Subject: Installation of a pneumatic tailwheel in exchange for the tailskid.

Affected gliders: All ASK 13s.

Fig. 1

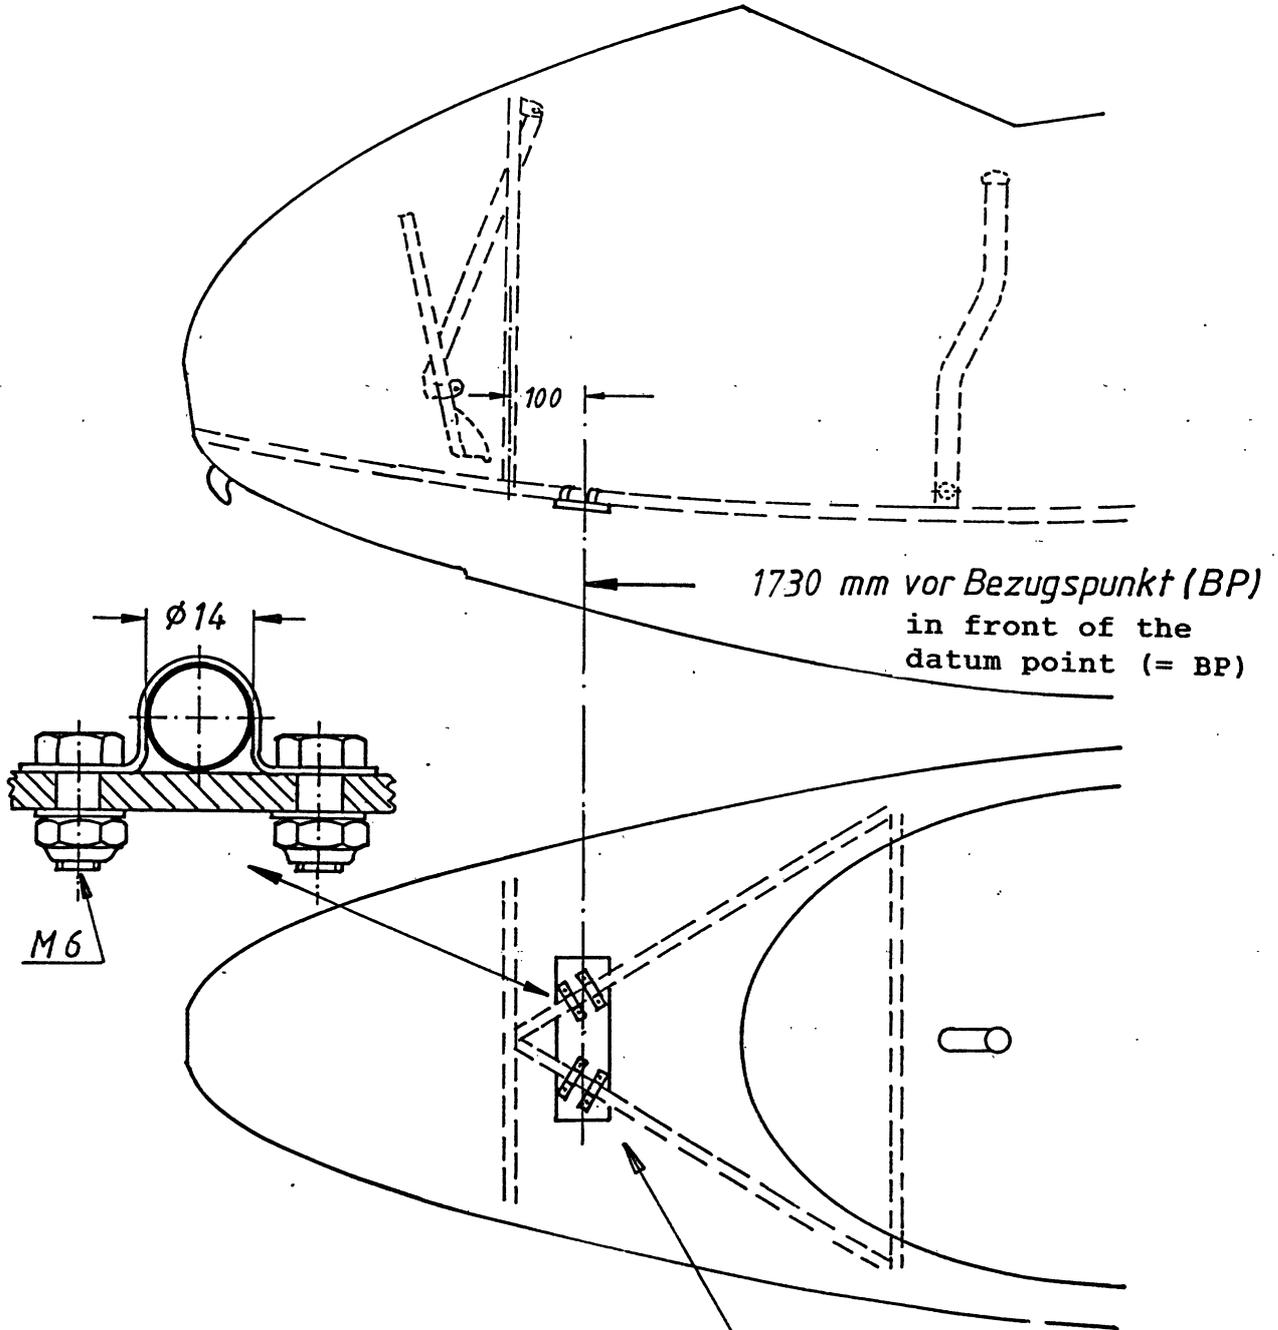
Action: According to drawing "Installation of pneumatic tailwheel" dated Feb.1, 1986, the fuselage is modified and the tailwheel installed. Depending on the new C.G. position a corresponding trim mass must be fixed in the fuselage nose below the front foot panel (see Fig.1).

Mass and C.G.: Owing to this modification the mass of the non-lift producing parts is increased by approx. 250 g and the C.G. is moved back by approx. 3 mm (0,12 in). Therefore, it is necessary to redetermine the mass and C.G. data. If the result of the C.G. weighing shows that the permissible C.G. range is exceeded, the short mass must be calculated and a corresponding trim weight must be fixed in the fuselage nose (see Fig.1).

je nach Schwerpunktlage Trimmasse an den
Abstreifungen unter dem Trittbrett montieren !

According to the measured C.G. data the corresponding
trim mass must be fixed at the bracings below the foot panel!
